Appendix G – Proposed Permit Modifications

Recommended Permit Modifications Related to: Reporting (ROWD Section 4.1)

Figure 6. 1. Compliance Pathways

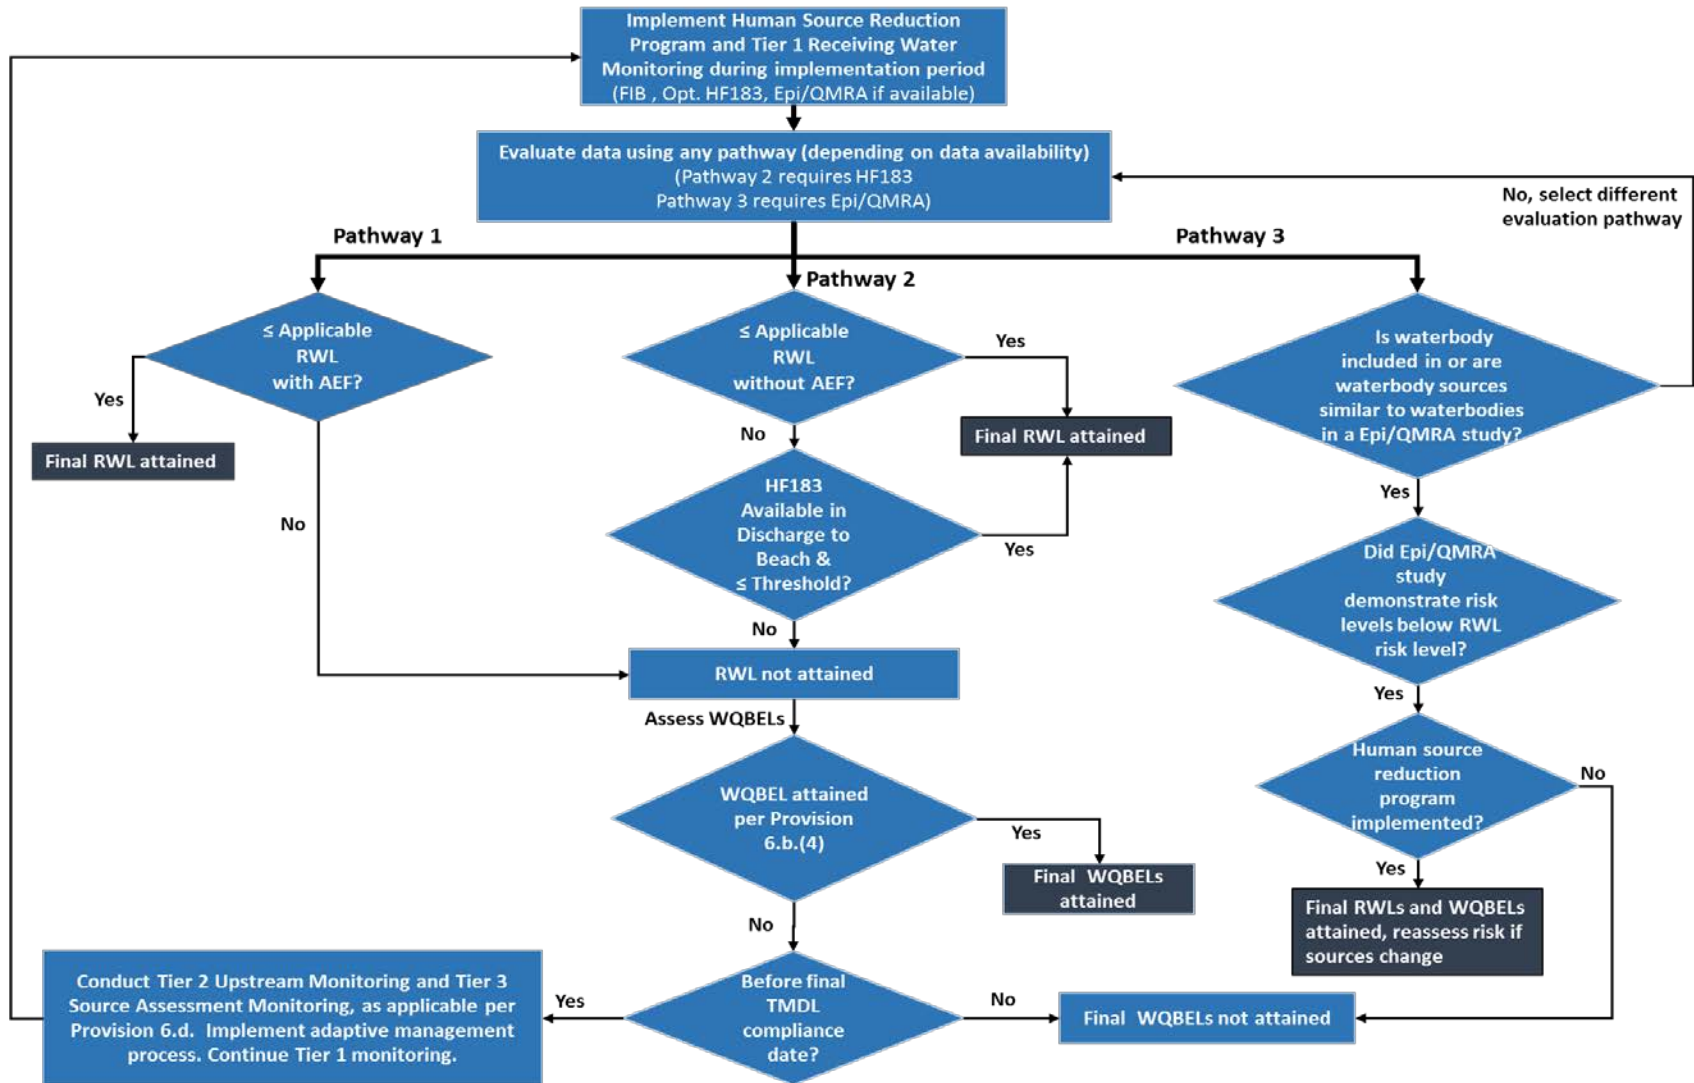
(a) TMDL compliance can be determined through any one of three compliance pathways, which are assessed using monitoring data, as shown in Figure 6.1. Compliance with the receiving water limitations and effluent limitations may be demonstrated through the following options, which incorporate the three compliance pathways:

- (b) Compliance with the final receiving water limitations, on or after the final TMDL compliance dates, may be demonstrated through an assessment of available monitoring data using any of the three compliance pathways shown in Figure 6.1. Each pathway requires collection of different types of monitoring data, listed below. Because any of the pathways can be used for compliance, there is no requirement to collect all types of data. However, if the necessary data for a given pathway are not collected, that pathway cannot be used for compliance purposes until the required data are available.
